HARTZELL PROPELLER INC.
SERVICE LETTER
TRANSMITTAL SHEET
HC-SL-61-61Y

**Propeller - Overhaul Periods and Service Life Limits for
Hartzell Propeller Inc. Aviation Components -
Propellers, Governors, Accumulators, and Propeller Damper Assemblies**

October 02, 2017

Revision 11 is issued to change the following:

**Aluminum Hub Propellers on Reciprocating Engines Identification - Compact Series
Figure 3**

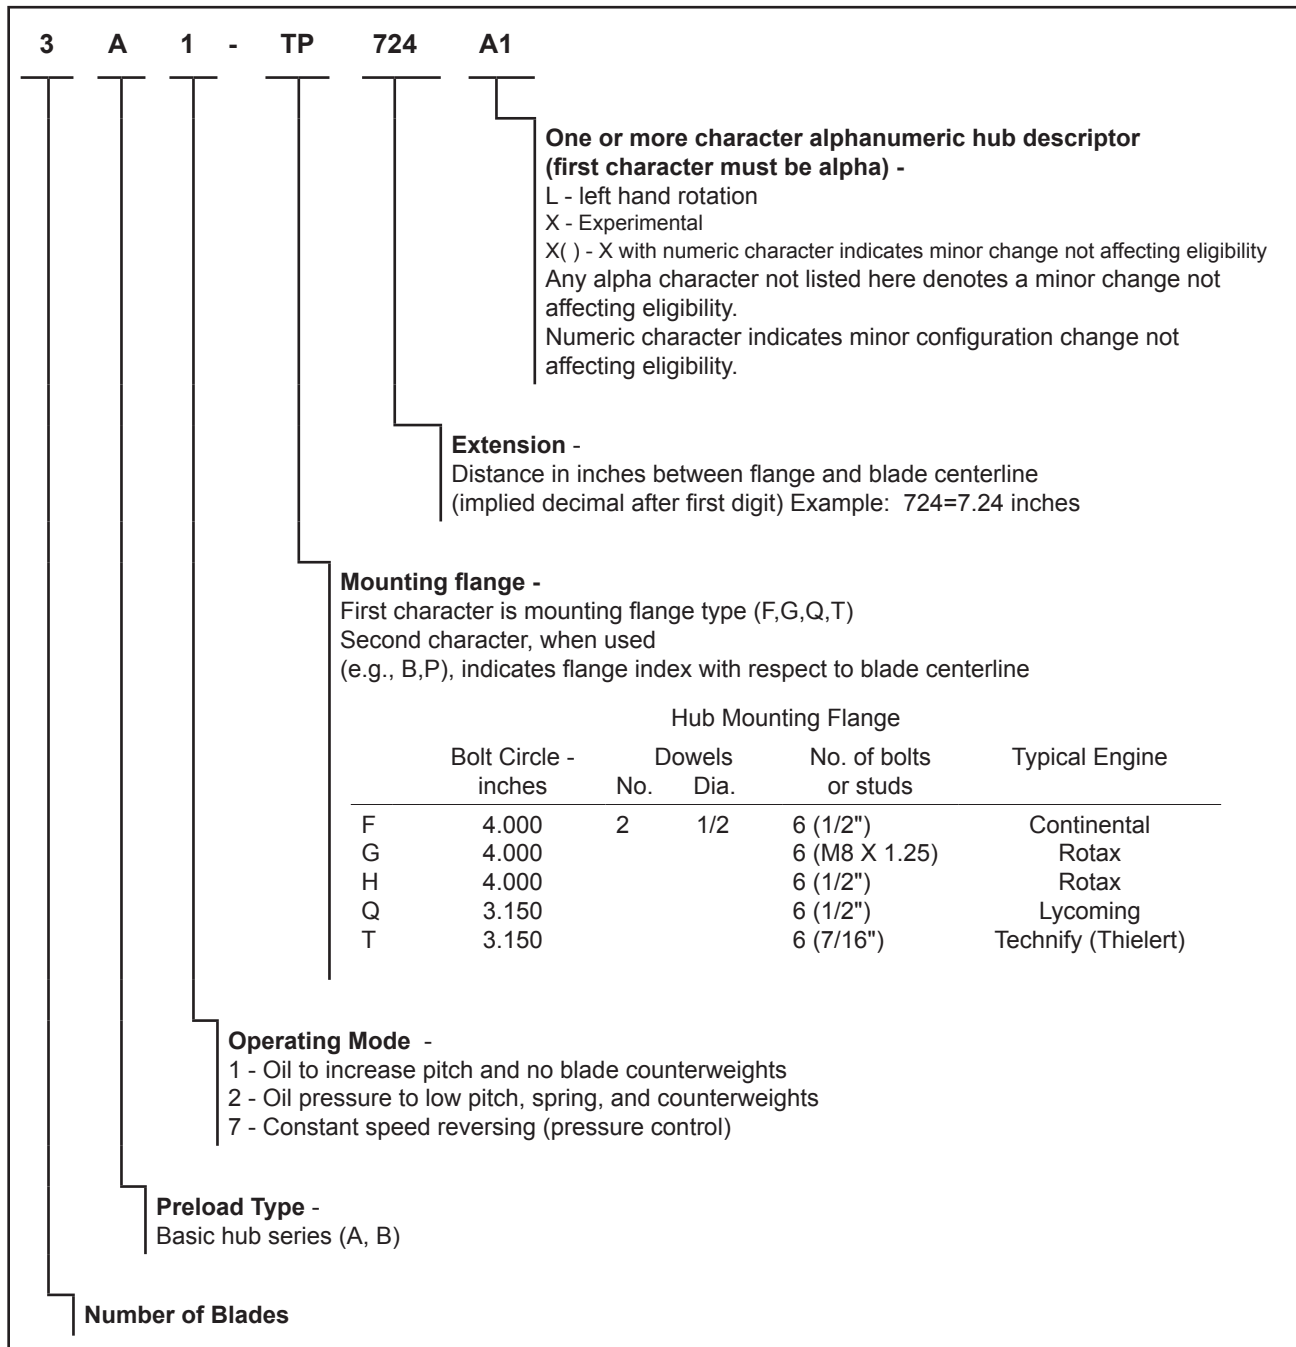
- Revised Figure 3, "Aluminum Hub Propellers on Reciprocating Engines Identification - Compact Series"
- Revised Figure 5, "Aluminum Hub Propellers on Reciprocating Engines Identification - Raptor Series"
- Revised Table 5, "Overhaul Periods for Aluminum Hub Propellers on Reciprocating Engines - Raptor Series"
- Revised Table 7, "Overhaul Periods for Aluminum Hub Propellers on Turbine Engines - Lightweight Series"
- Made other language/format changes
